2.0 CONTENTS	2
3.0 PROJECT DATA	4
4.0 SITE PLAN	5
5.0 ZONING DATA	6
6.0 DESIGN GUIDELINES	8
7.0 DESIGN REVIEW -EDG	10
8.0 DESIGN REVIEW RESPONSES	
massing	12
entry and streetscape	13
site	14
materials	16
9.0 DEPARTURES REQUEST	18
10.0 ARCHITECTURAL DESIGN	20
building elevations	20
floor plans	24
building section	28
perspective views	29
landscape design	31
11.0 APPENDIX	37

SITE ADDRESS	4401, 4411, 4419 FREMONT AVE N
PARCEL NUMBERS	569350-1505, 569350-1345, 569350-1362, 569350-1375
PROJECT NUMBER	3039251-EG, 3039107-LU

ARCHITECT	Atelier Drome Architecture 119 S. Main St. Suite 310 Seattle, WA 98104
CONTACT	Michelle Linden michelle@atelierdrome.com

EDG BOARD RECOMMENDATION

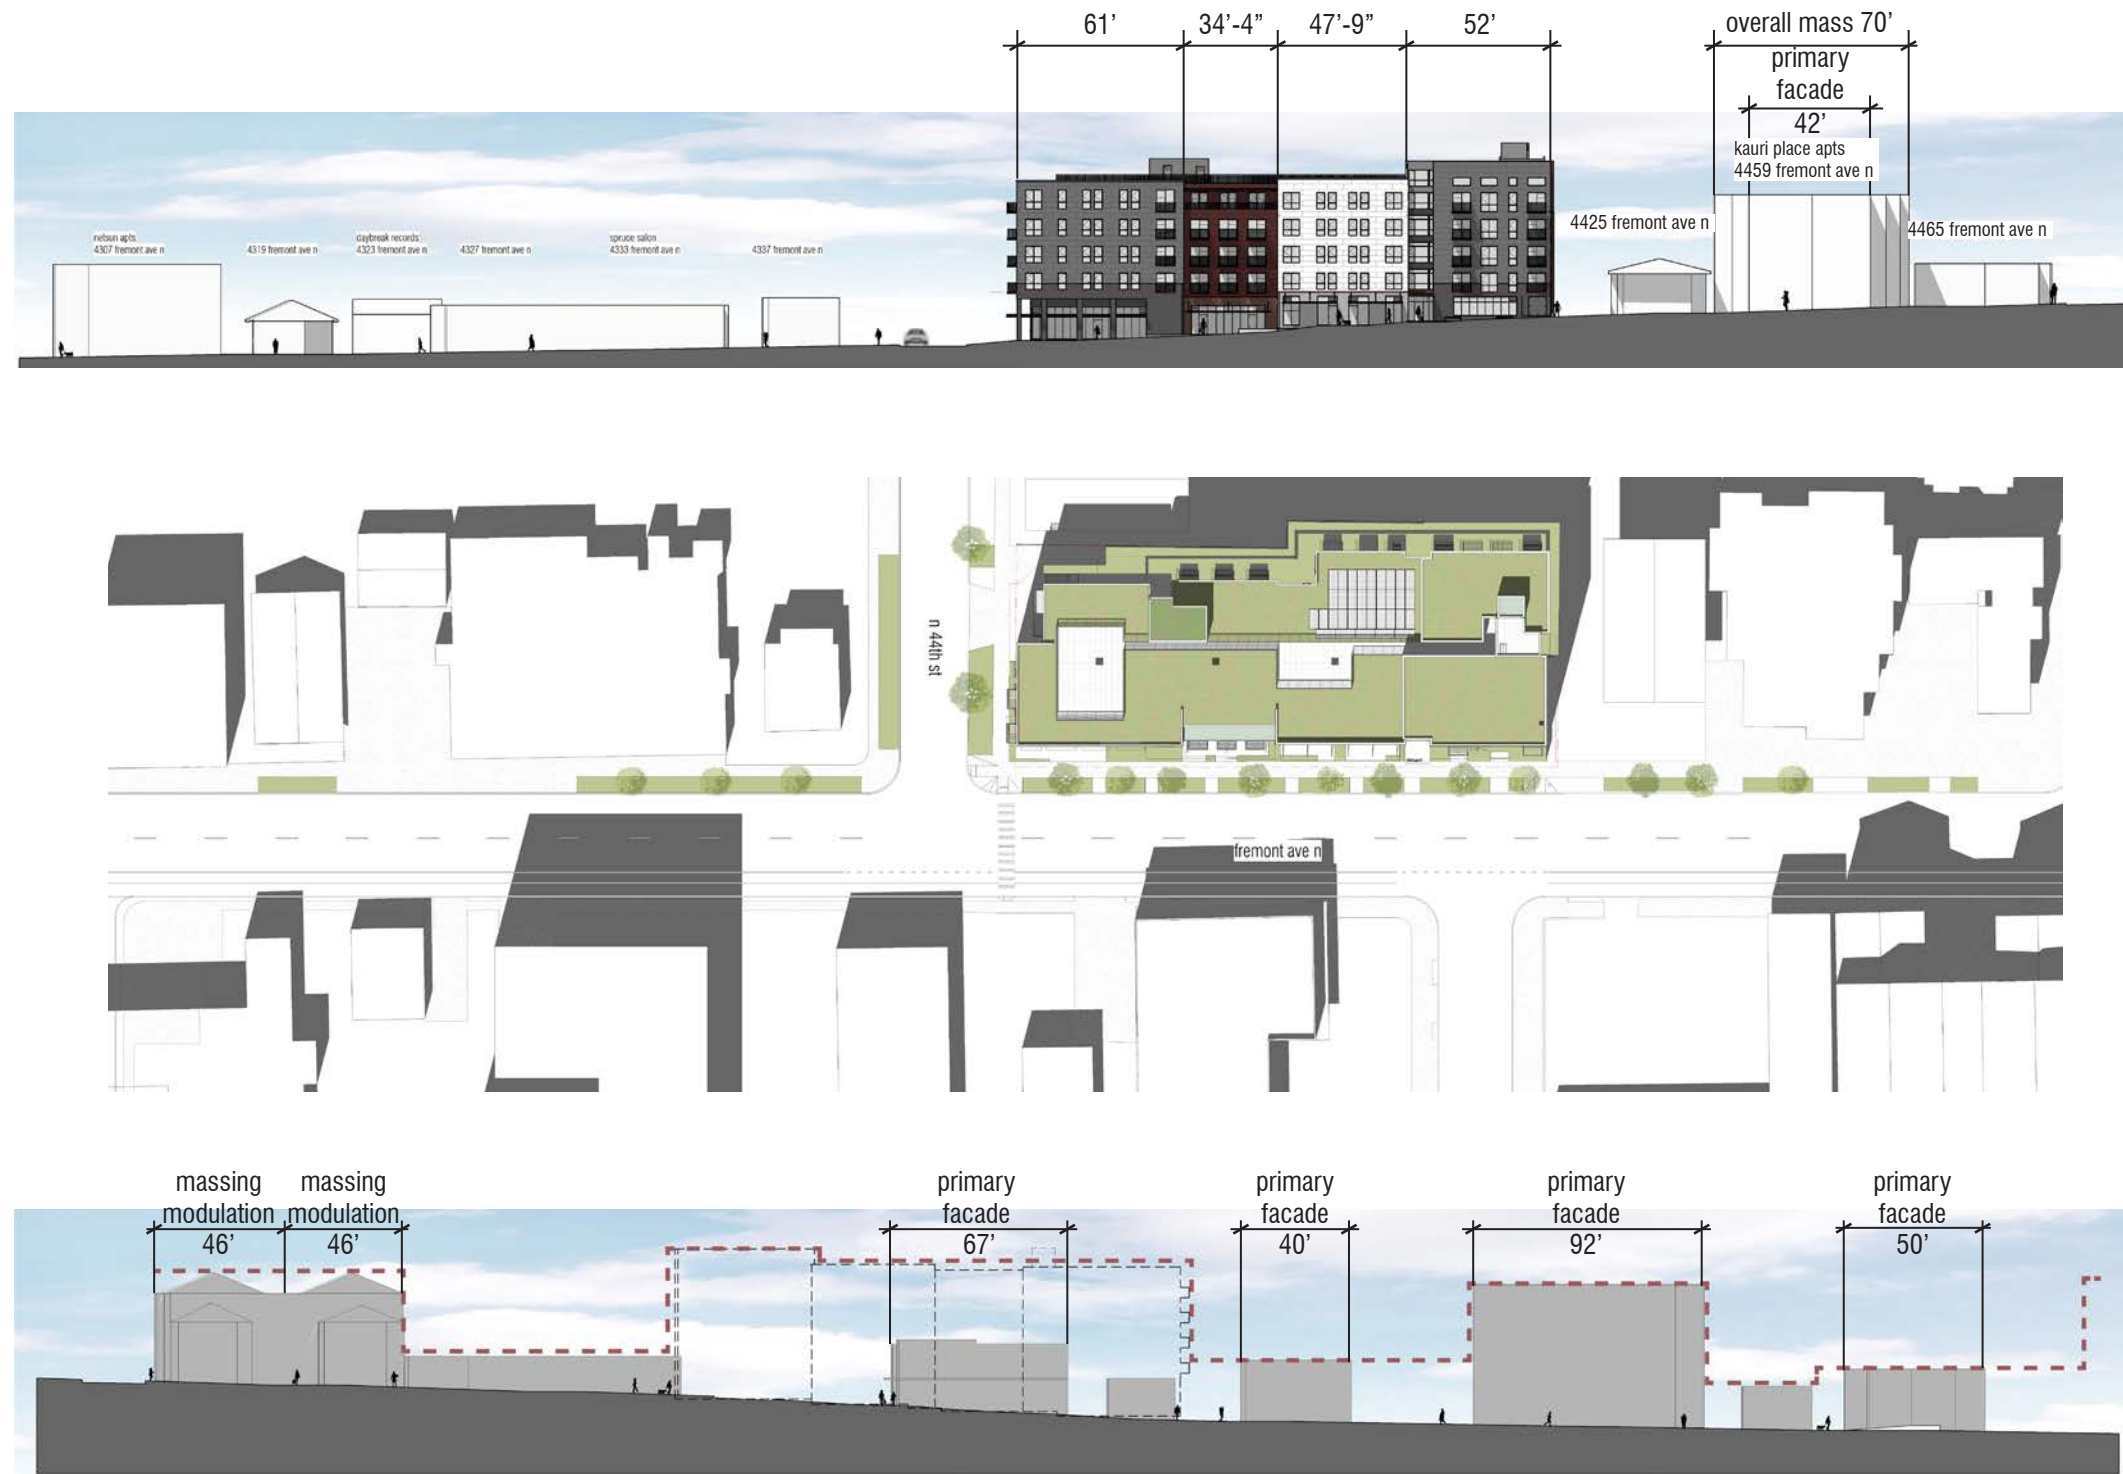
In agreement with public comment, the Board unanimously supported Option 3, the applicant’s preferred massing option. The Board appreciated the illustrations of the progression of design thought for the massing options, as shown on page 25 of the EDG packet, clarifying a refinement of massing form from a basic Code-compliant option to the best context-adapted option.

The Board specifically supported the rhythm of vertical modulations in Option 3, which break down the long front façade length into contextually scaled modules. The Board noted that the proportions of the modulations appeared logical as well as aesthetically pleasing in the overall façade composition.

The Board noted that although the graphics appeared to create a contextual scale, the building was not shown in context with other neighborhood structures for comparison. The Board requested the scale of modulation be shown with actual context in the Recommendation package to demonstrate the modulations are staying true to the massing and scale concept.

The Board noted that Option 3 emphasized the corner with a unique massing volume with a ground-level commercial unit wrapping substantially onto the side street.

The Board especially appreciated that the vertical modulations that provide scale on the east street-facing frontage are also articulated on the west (rear) façade, creating relatable scale at the residential zone transition.

The Board additionally supported the 11’ setback along the rear property line and the lower height of Option 3 (as compared to the grade-averaged Option 2 massing) as contributing to the rational design response along the zone transition.

The vertical modulation presented in the approved EDG concept has been maintained by the design team. In evaluating the neighborhood structures for comparison, there is not a consistent breakdown in façade width or modulation. However, when analyzing the larger scale apartment complex to the north, as well as the more developed side of the street – the majority of developments have a primary façade or major massing move between 40’ and 70’ in width. This is consistent with the modulation presented in our proposed project.

The design team has maintained the preferred corner element with the ground floor wrapping on two sides, the vertical modulations extending through to the west of the site, the 11’ rear yard setback, and the split height of Option 3 as requested by the board.

studies @ grade transition

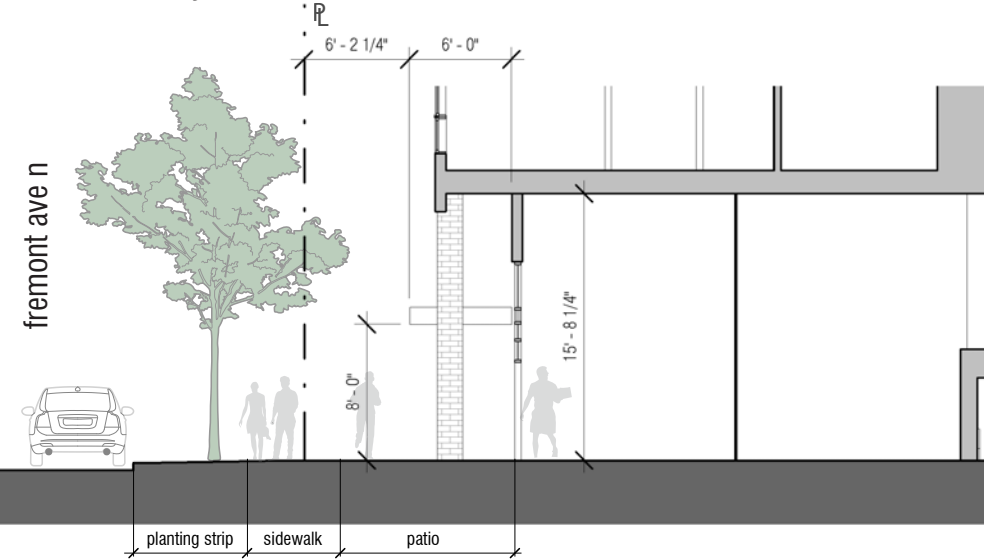
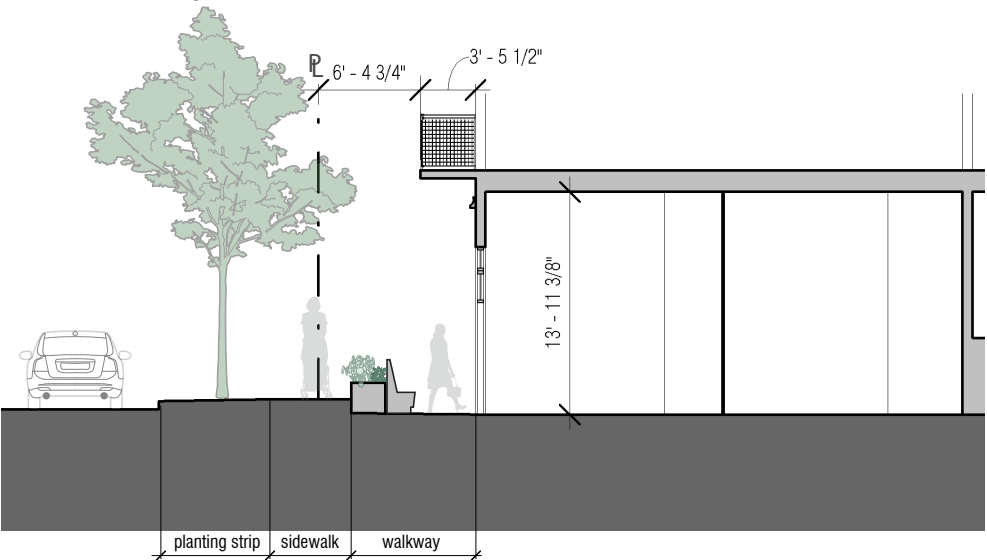
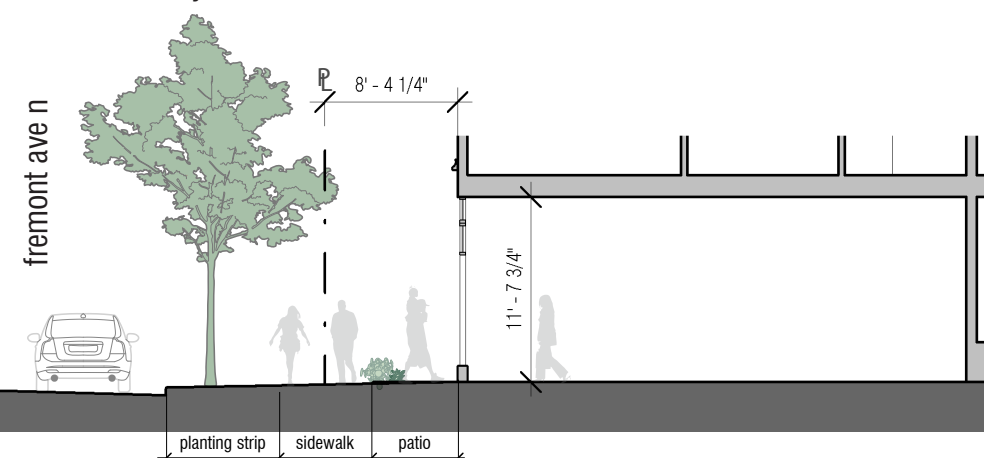
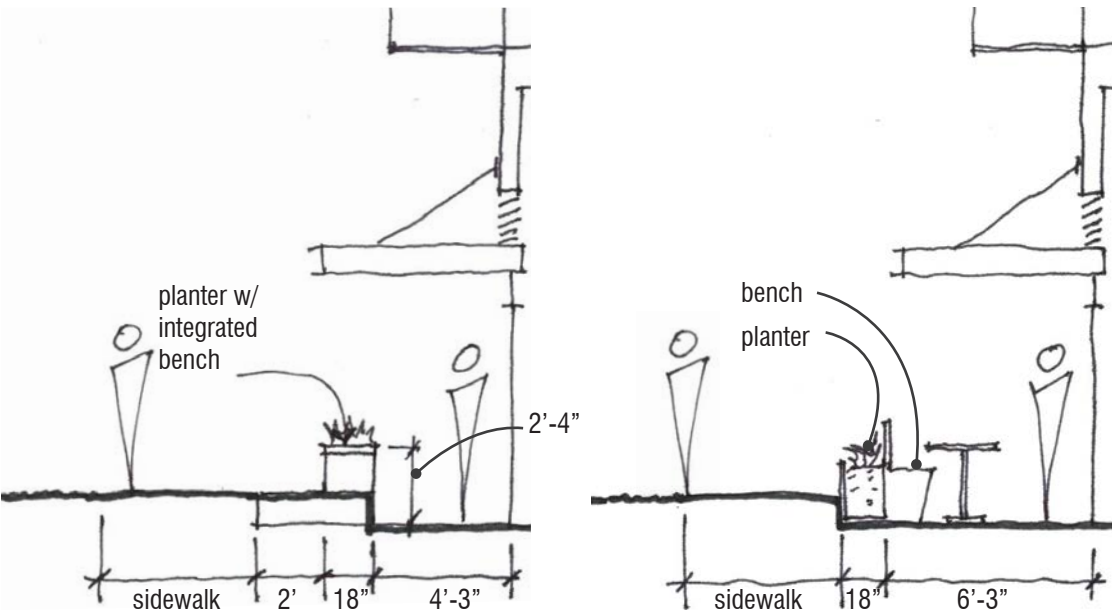
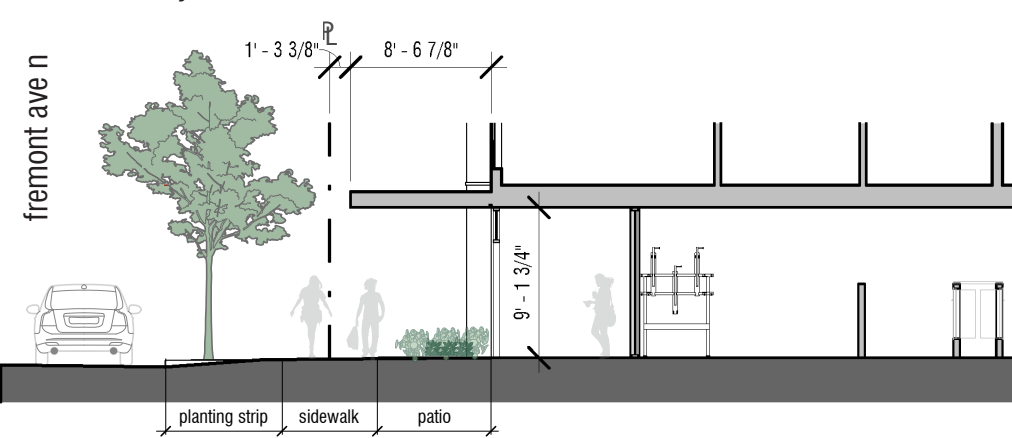
The Board specifically supported the street-level layout of Option 3 where the commercial units step floor levels to meet the grades as the sidewalk climbs along Fremont Ave N. The stepped ground levels, aligned with the upper-level modulations, create a legible progression of spaces along the frontage.

The Board also supported the differentiated façade treatments at the ground level that create scale in relation to the other storefronts in this neighborhood commercial area.

The Board specifically supported the setback of the corner commercial unit at both the Fremont Ave and N 44th St frontages, allowing for commercial spill out space and creating a visually porous edge between the public and private realms at the corner.

The Board supported the location of the residential entry at the northern edge of the structure long the Fremont Ave frontage. The Board noted that the location of the residential use was logical in terms of progression of the street level uses from commercial at the busy corner to residential at the north edge. They also noted that the entry was oriented towards the 'T' intersection with N Allen Pl for convenient access to the crosswalk.

Each vertical modulation is expressed with a similar material, with color aiding in distinguishing the massing modulations. At the ground plane facing the commercial street, the facades are all clad in brick – a nod to the pedestrian nature of the street as well as the historic precedent in the neighborhood. Above the commercial levels, a tone on tone material is applied in order to provide a cohesive vertical expression.

Windows and storefront vary at each commercial façade, relating to the fenestration above while still providing a cohesive expression.

At the corner commercial unit, spillout space has been increased for even greater activity. Additionally this space is distinguished from the others through the use of a wood storefront system.

SDOT requires sidewalk facing benches to be setback 2' from sidewalk reducing usable space

planter acts as a buffer at the grade transition, providing maximum usable patio at the commercial space

light & privacy study

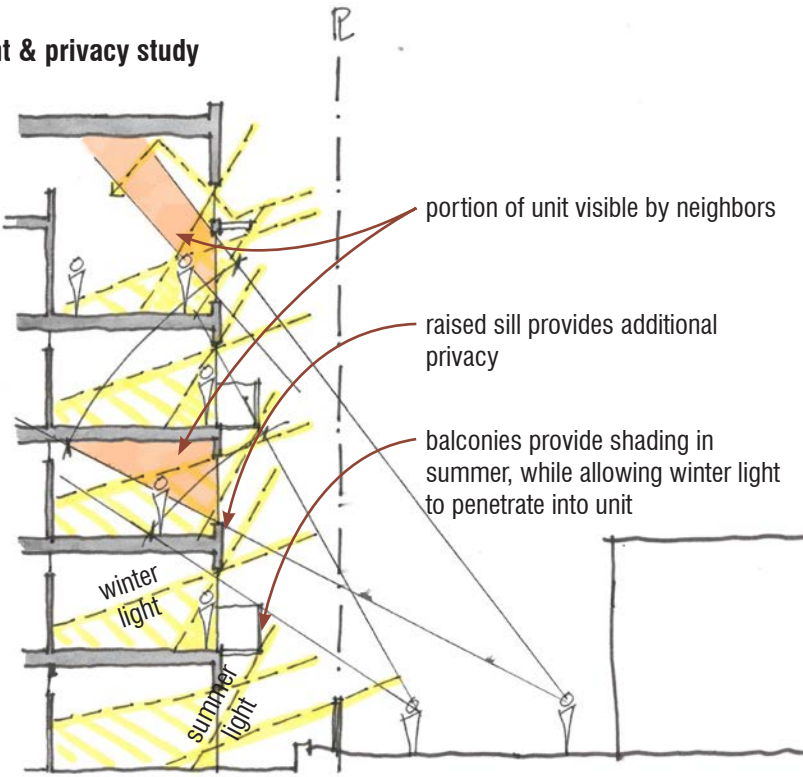
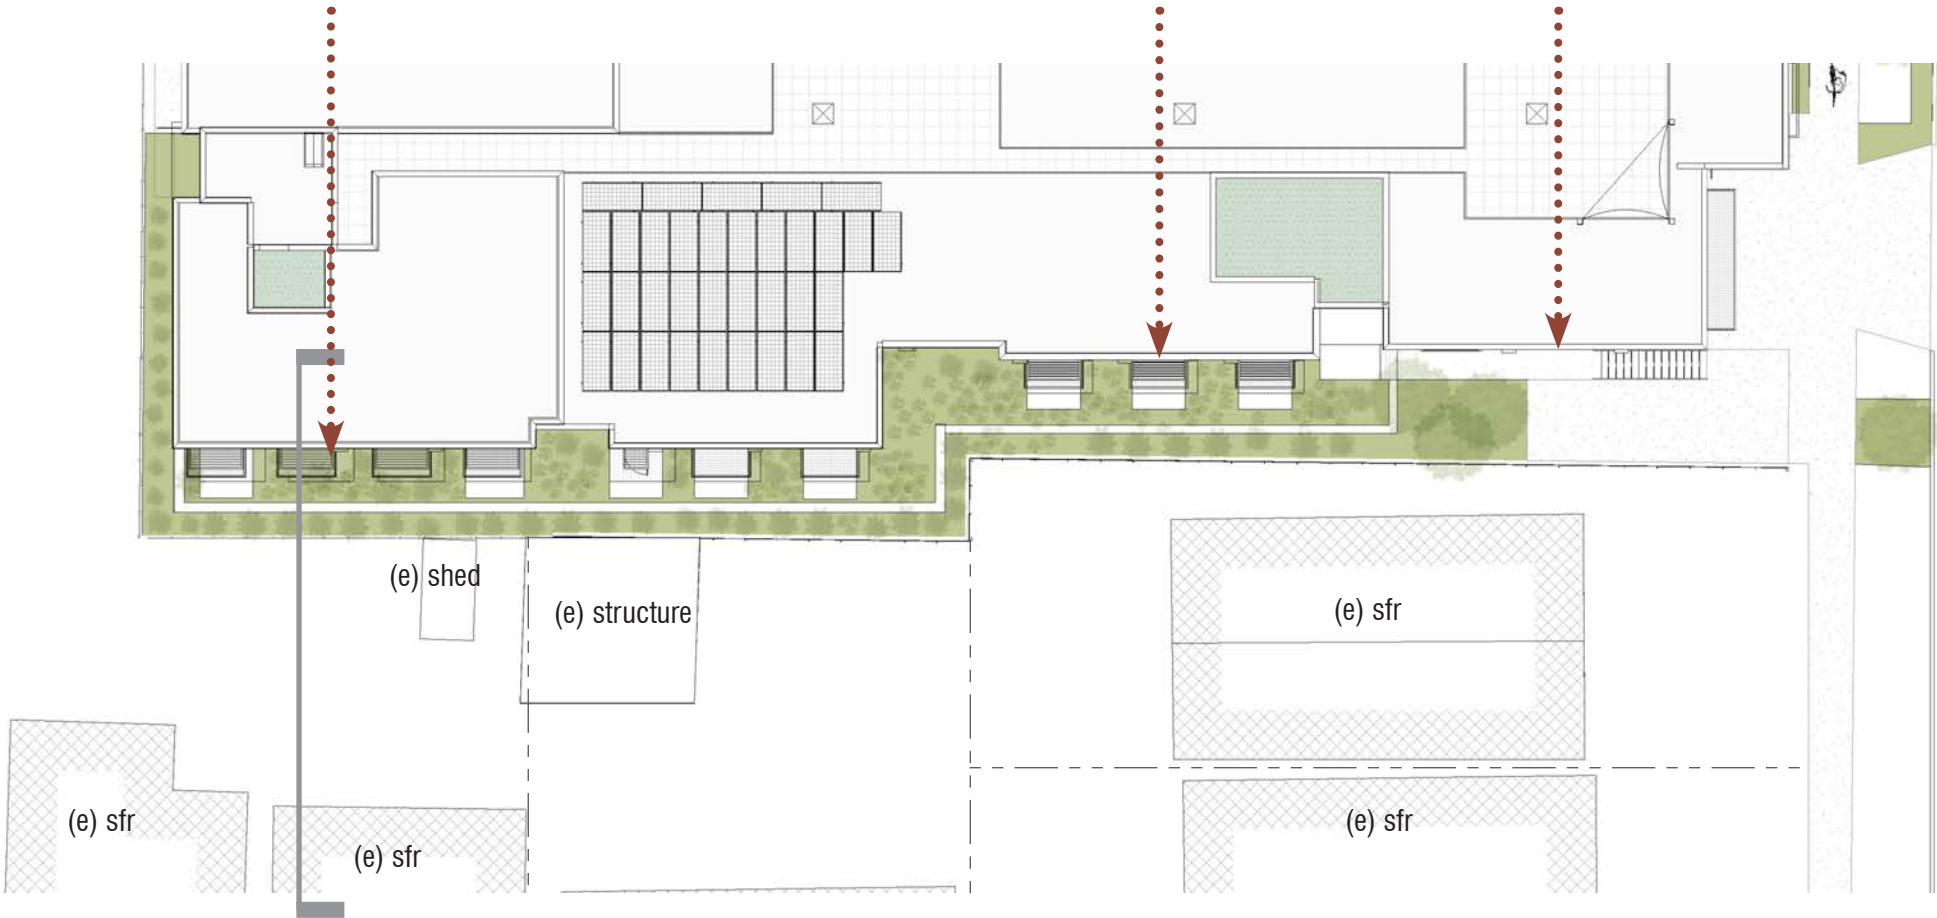
The Board discussed the possible addition of balconies as the design progresses and generally supported the potential inclusion of balconies on the west and south facades that could add activation along the street frontages.

The applicant noted that they would likely limit balconies on the west façade due to privacy concerns along the zone transition. The Board noted that balconies on the west façade could provide valuable amenity to units. They requested any balconies proposed on the west façade be studied to ensure impacts of sight lines, visibility and noise are limited on the adjacent residential properties.

combination of balconies & windows for increased privacy

combination of balconies / juliets to reduce impact on neighboring properties

reduced balconies @ areas closest to single family homes
